26 September 2023

Goterra

We are preparing this response to EPA's letter dated on 30 August 2023.

**Figure 1 Floor plan for the proposed processing units**

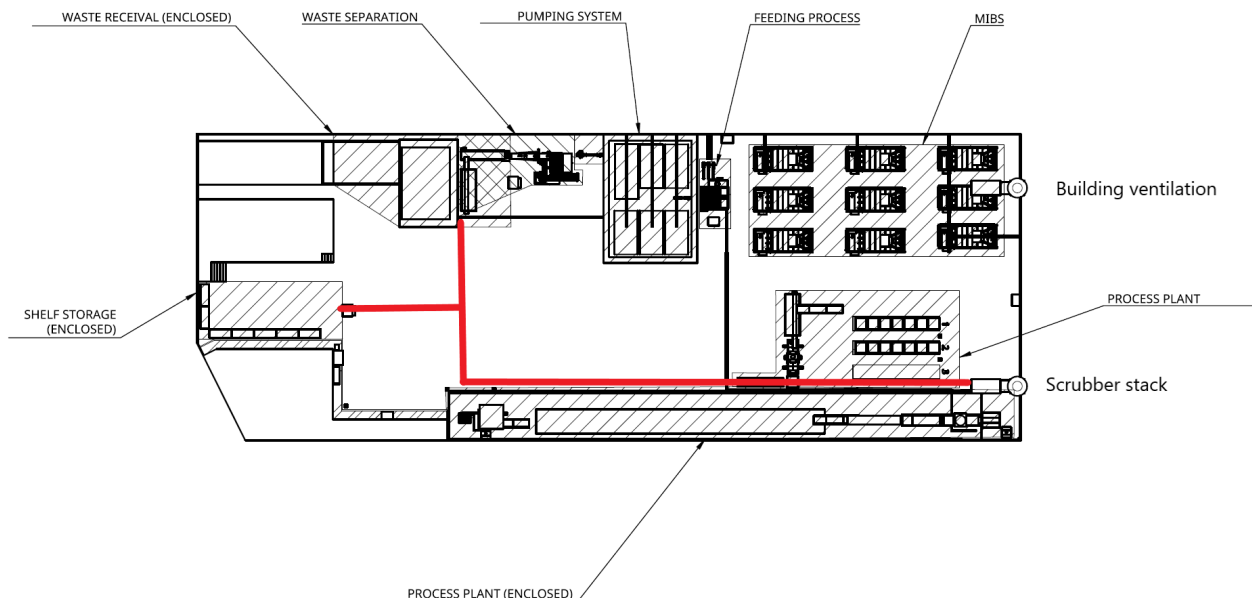
The factory at Hume is operated under natural ventilation condition. The proposed factory at Weatherall Park will operate within a giant warehouse shed under a mechanical ventilation condition. These processing units of waste receipt, process plant and storage room are all enclosed and ventilated

through a wet scrubber and impregnated activated carbon filters. This part of exhaust is then released at the back of the building via building ventilation fan. Modular Infrastructure Biological Service (MIBS), in the form of shipping containers, are left in the second half of the shed (see Figure 1). The processing units of waste separation and pumping system are sealed and are not considered as the odour sources. The exhaust from this area is then vented to outside the building via a second centrifugal fan scrubber stack.

The final design for the building is only two ventilation fans. There are no 10 stacks and 3 stacks to remove the heat which was in the early design. The odour report has now been amended to confirm the ventilation arrangement.

As per recommendation - Stack designs will exclude fitted hoods however this would have not impacted the dispersion model due to sufficient reduction in concentration within the building. From an odour dispersion point of view, it is also not necessary to install the fitted hoods for the exhaust fans.
